MIDLAND PROJECT -
ALAB-106 MONTHLY REPORT FOR NOVEMBER 1980
DOCKET NOS 50-329 AND 50-330
FILE: 0.4.6 UFI: 70*01 SERIAL: 10088

In accordance with Condition of Memorandum and Order ALAB-106, dated March 26, 1973, and Amendment No 1 of the Midland Plant Construction Permit, enclosed are ten copies of the following documents written or closed during the month: Bechtel Nonconformance Reports, sheets from the Bechtel Nonconformance Report Log; Bechtel Quality Action Requests; Babcock & Wilcox Reports of Nonconformity; B&W ISI NCR's; and Consumers Power Company Nonconformance Reports, Audit Finding Reports, Quality Action Requests, and Corrective Action Reports.

LOG OF NONCONFORMANCE REPORTS

DETAIL-A

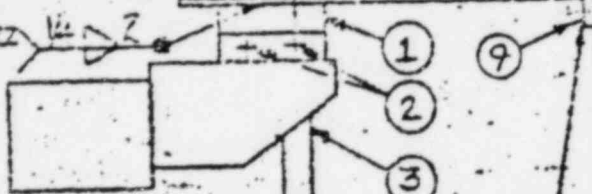
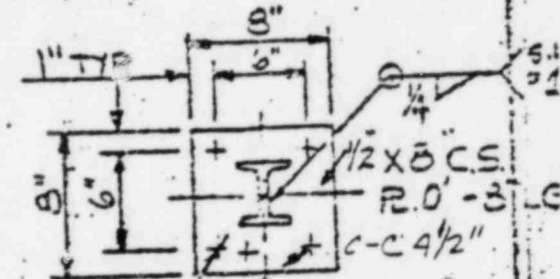
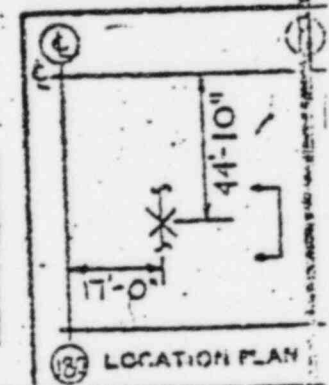
CONDITION: HANGER 6" IE6B-6-H11 SKETCH I-638-14-19 SHEET 20.

NCR 3215
1926 F

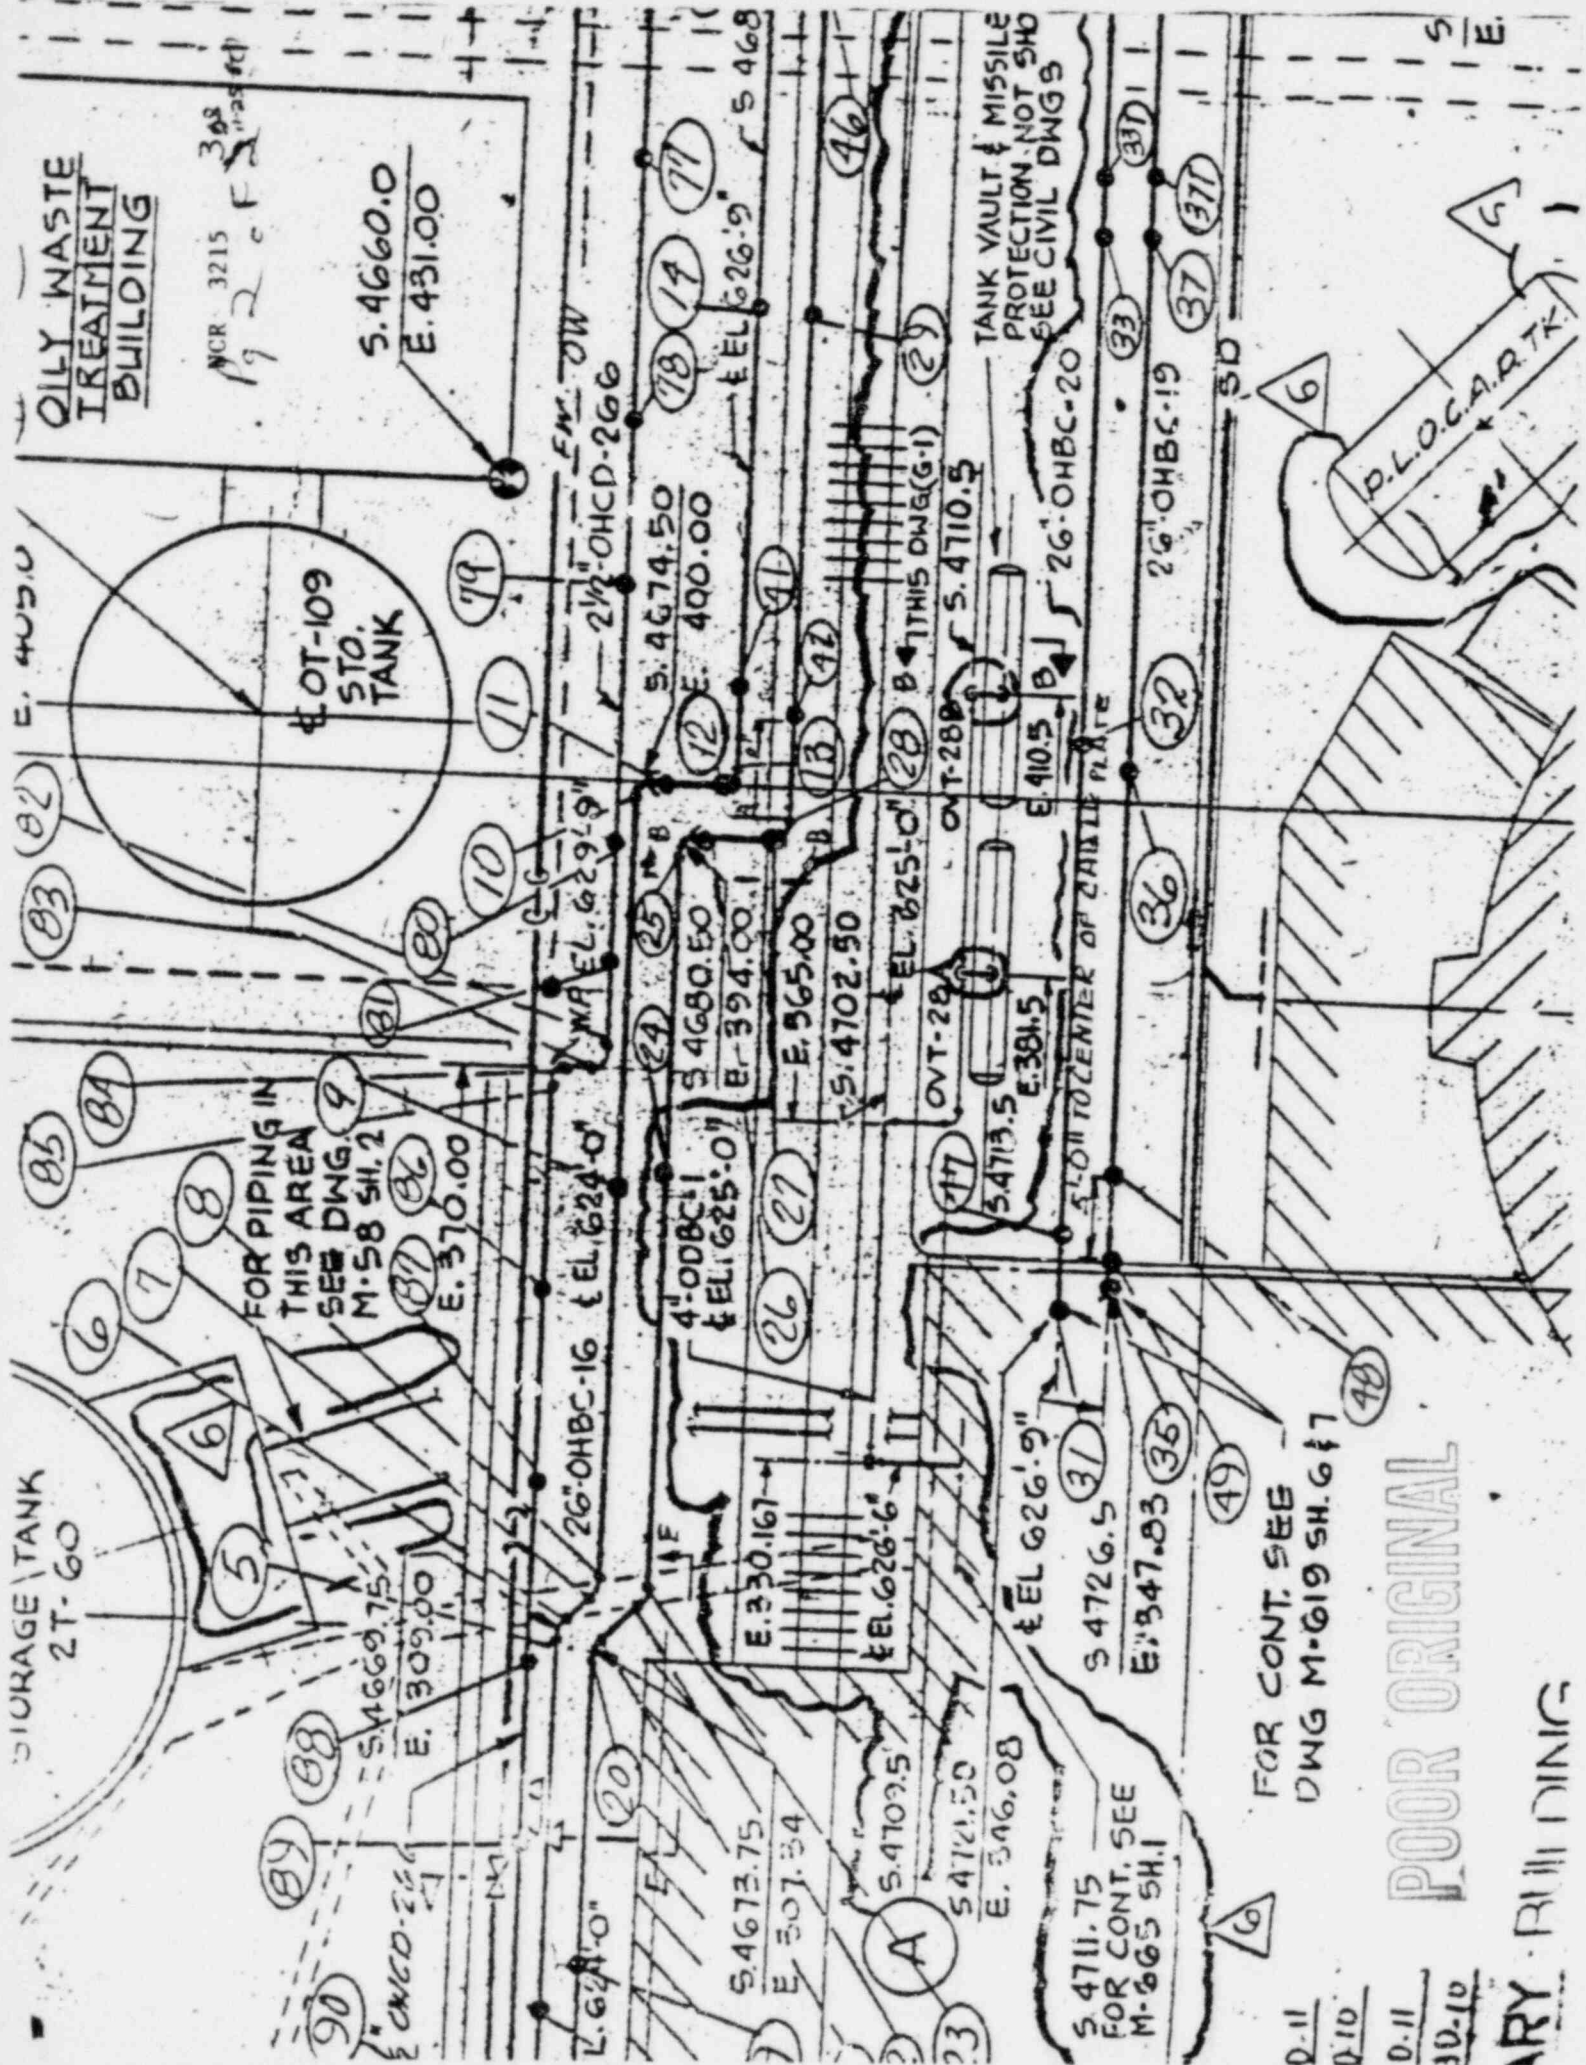
16. NONCONFORMING CONDITION: REQUIREMENT: PIPING CLASS SHEET M-4B1(Q) REV18, CLASS OBC STATES "PIPE FOR ODBC-001 & ODBC-002 TO BE SCHEDULE 120". CONDITION: TWO(2) 900# WELD NECK R.F. FLANGES, SCH 80 WERE INSTALLED ON PLANT SIDE OF TANKS OUT-20A & B. "Q" LIST No 4,65 TWO(2) HOLD TAGS APPLIED TO FLANGES

RECORD OF LOCATION FOR TEMPORARY ATTACHMENTS AND BASE METAL REPAIR

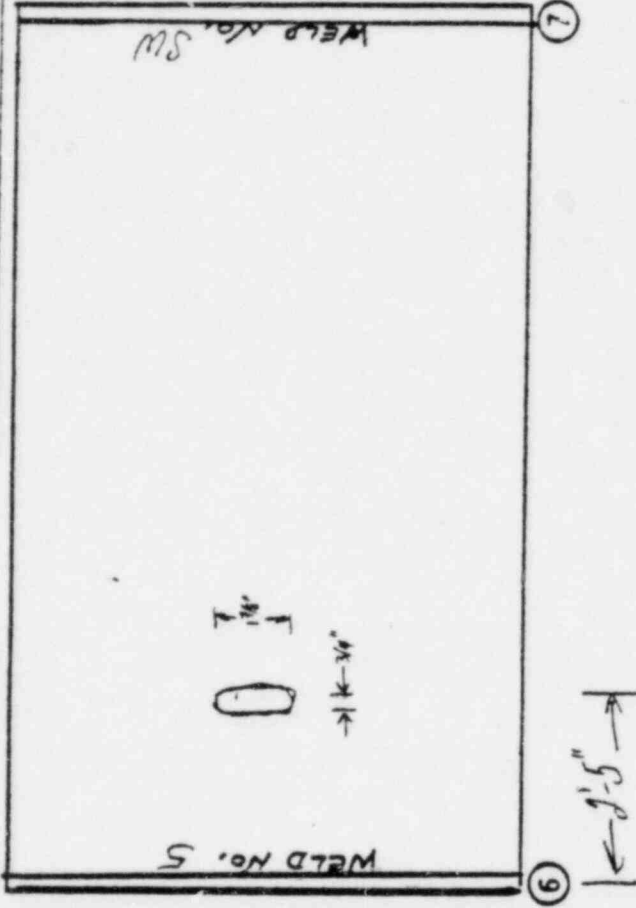
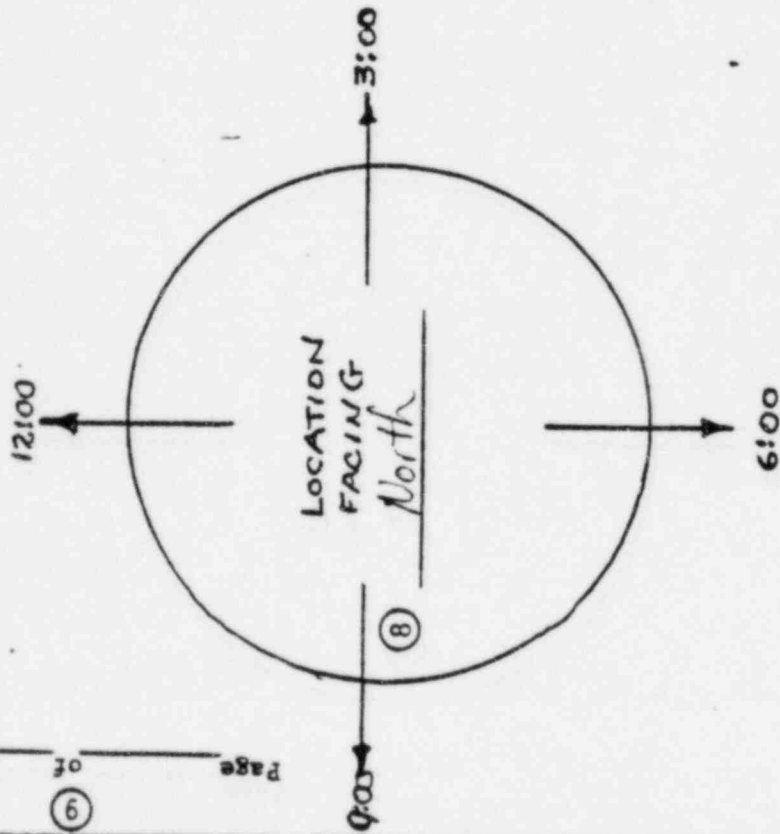
1. PROJECT NAME Midland		JOB NO. 07220		19. NO. 3216	20. PAGE 1 OF 2
2. UNIT(S) 2	3. DRAWING/PART NO. M6195H 3	REV 7/82	4. ITEM DESCRIPTION Arc Gauge in Pipe Construction

X Cut Rebar
WALL @ 5.6 LINE
EAST FACE - LOOKING WEST

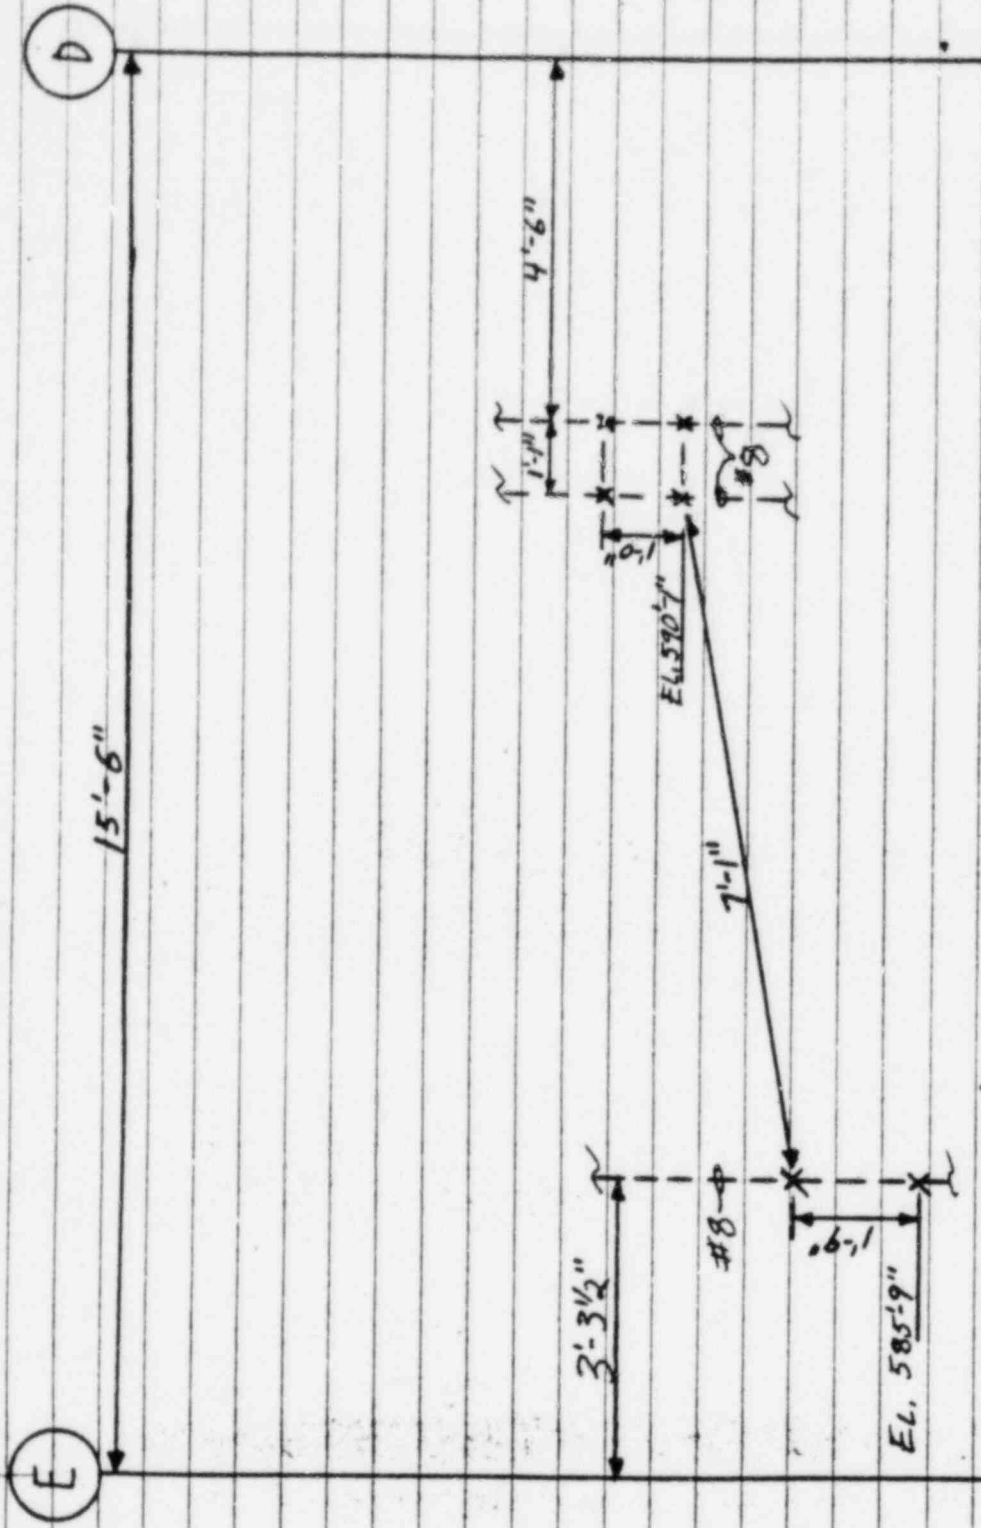
1. PROJECT NAME MIDLAND		JOB NO. 7220		19. NO. 3221	20. PAGE 1 OF 2	
2. UNIT(S) COMMON	3. DRAWING/PART NO. N/A	REV N/A	4. ITEM DESCRIPTION CUT REBAR	5. ITEM LOCATION WALL @ S.G., EAST FACE EL. 5.88, 3' NORTH OF E

22. <input type="checkbox"/> Field Engineering Disposition <input checked="" type="checkbox"/> Field Engineering Recommended Disposition to Project Engineering PROJECT ENGINEERING TO EVALUATE. Paul Dagnan 11/24/80

SLAB @ (6.9) & (D) EL. 584'-0"
Rm 129

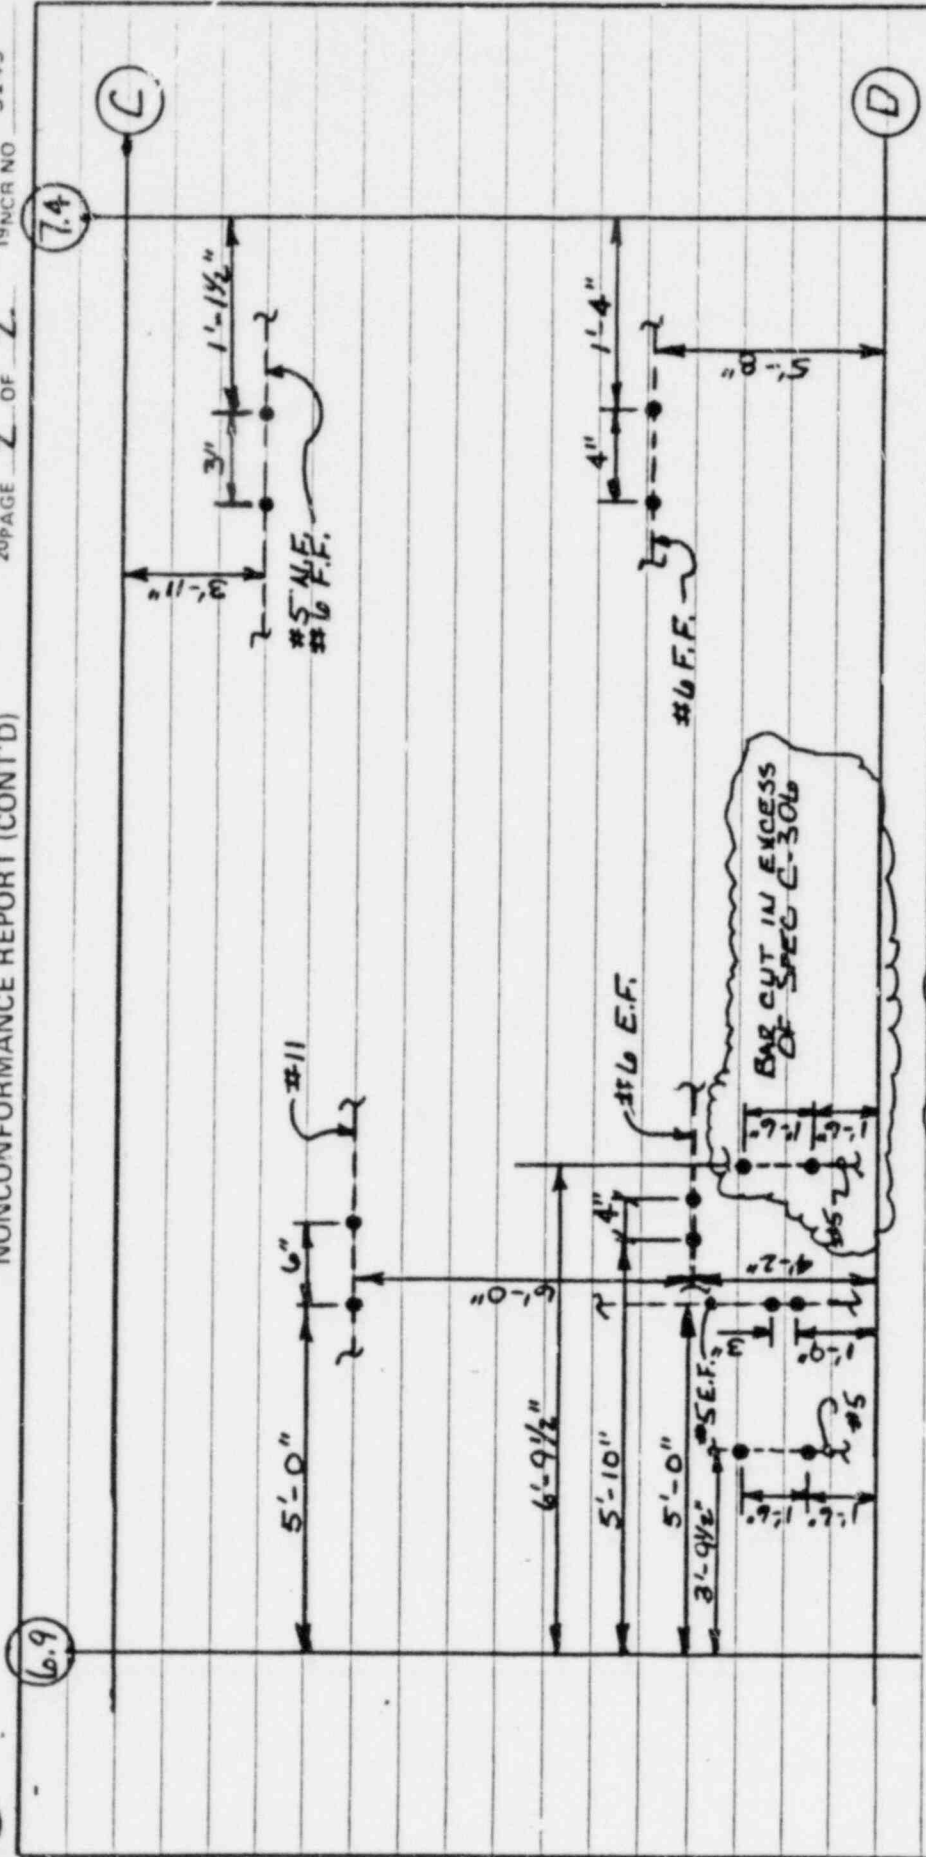
23. PROJECT ENGINEERING DISPOSITION							
3 TOP BARS WHICH HAVE BEEN CUT ARE TEMPERATURE BARS. THE REMAINING REBARS ARE ADEQUATE FOR TEMPERATURE & SHRINKAGE REQUIREMENTS. (CALC 23 C. 3) NO COORDINATION REQUIRED.							
ETB. JAP P. Pruevy-QE-10/22/80				26. QC ACCEPTANCE James G. Seach 11/4/80 QC ENGINEER DATE AUTHORIZED INSPECTOR DATE

NOTE: This sketch to be used only for alignment not orientation of tie plates.

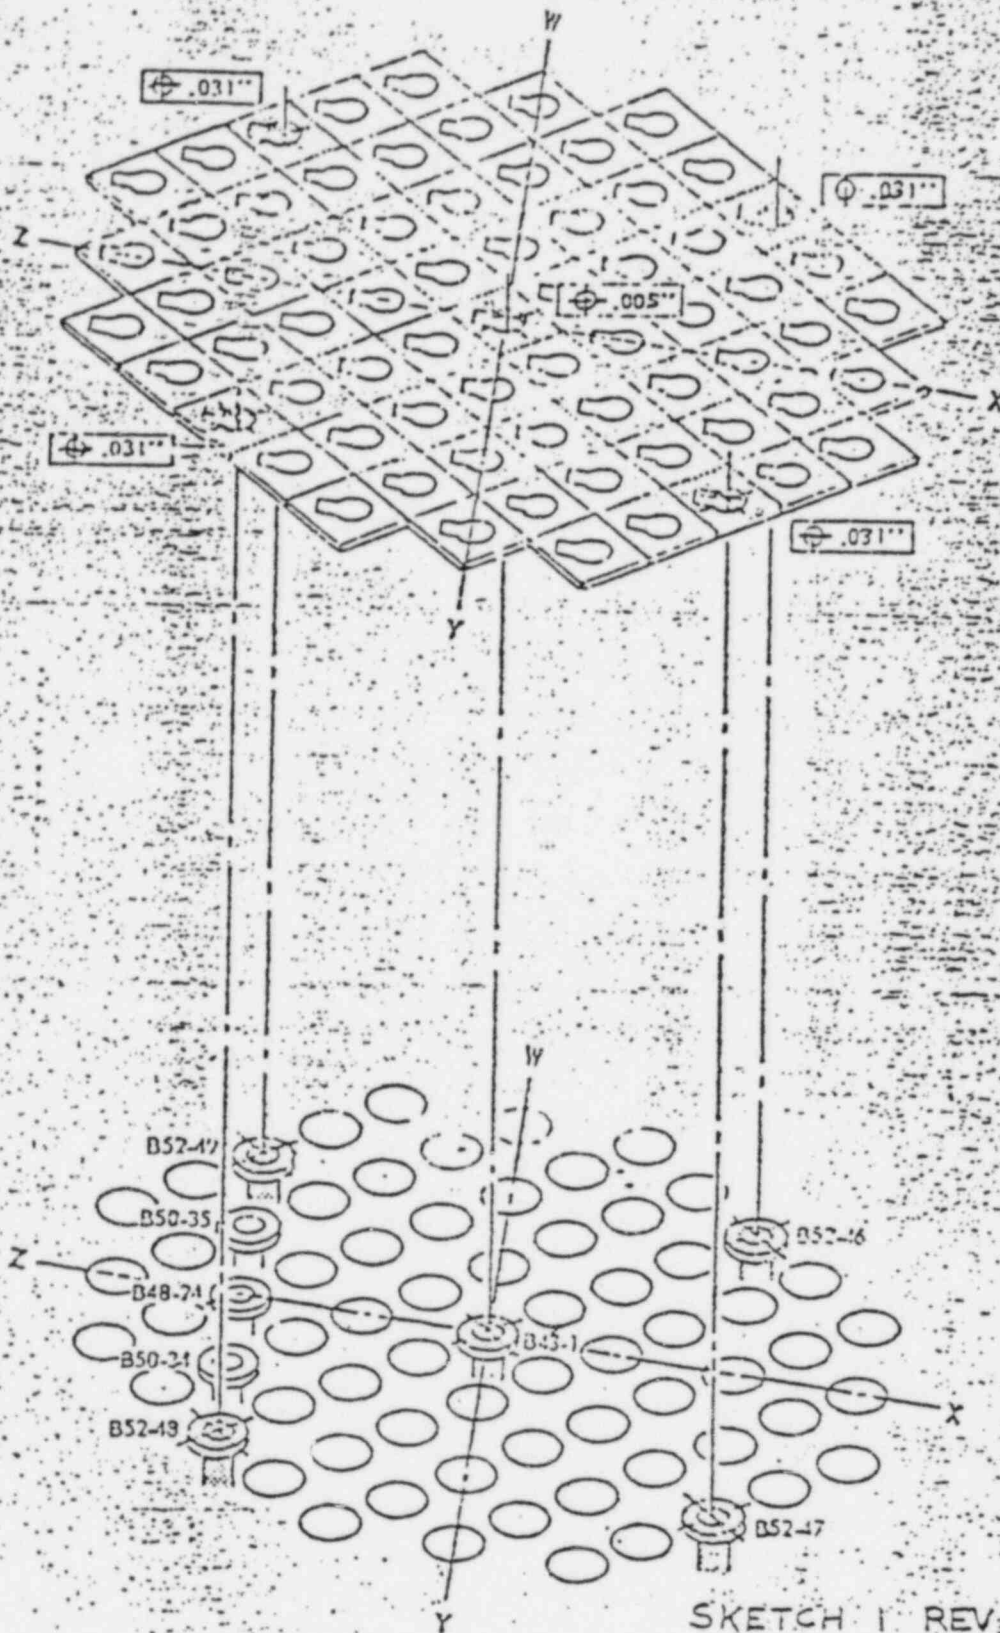
9. PROCEDURE NUMBER FCP #64		12. PRIOR REPORT OF NONCONFORMITY? N/A		
10. SPECIFICATION NUMBER FS-III-1C		11. DRAWING NUMBER 196893E, Rev. 0		
13. DESCRIPTION OF NONCONFORMITY The tie plates on service structure platform are installed incorrectly. They are 180° out of rotation as required by drawing. It appears that they were inadvertently installed & inspected per Sketch #1 attached to FCP #64. This sketch is included in the FCP for alignment only and was not intended to be used for the orientation of tie plates. Rev 11-20-80

26. CORRECTIVE ACTION Revise Sketch #1 of FCP #64 adding a note stating "This sketch to be used only for alignment not orientation of tie plates". <u>Walter Linn</u> FIELD PROJECT MANAGER DATE 11/21/80
